DIXIE-MARCO CO, INC.
SERVICE BULLETIN #139

MODELS: All CFT Open Coolers for which complete Replacement Refrigeration Systems are furnished.

SUBJECT: Relocation of two (2) holes - - As Shown - - Fig. 1.
(If necessary).

Fig. 1. Fan Housing Cover

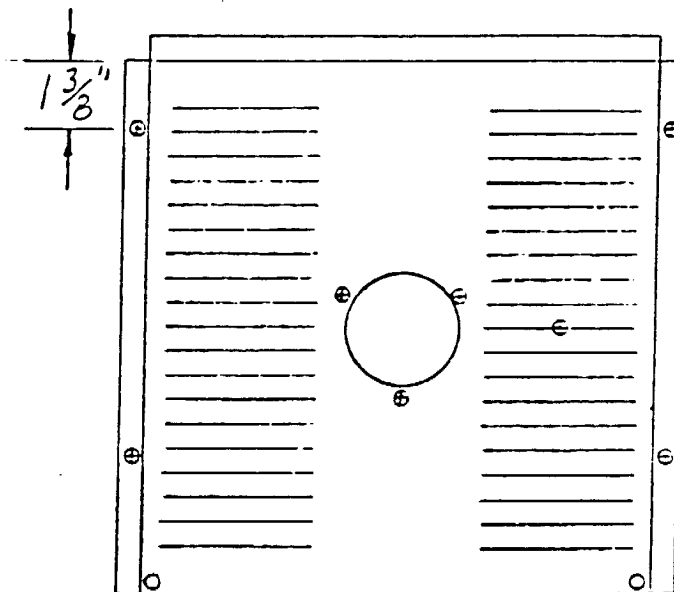
REASON: To prevent the ends of the screws from entering the evaporator coil and causing a refrigerant leak.

- DO THIS:
- Before installing a replacement refrigeration system check to see if the hole dimension (right and left sides) is 1-3/8" as shown - Fig. 1.
 - If not (remove original screws) drill two (2) new holes in accordance with dimensions - - Fan Housing - Fig. 1.
 - Secure assembly with two (2) screws provided in Kit.
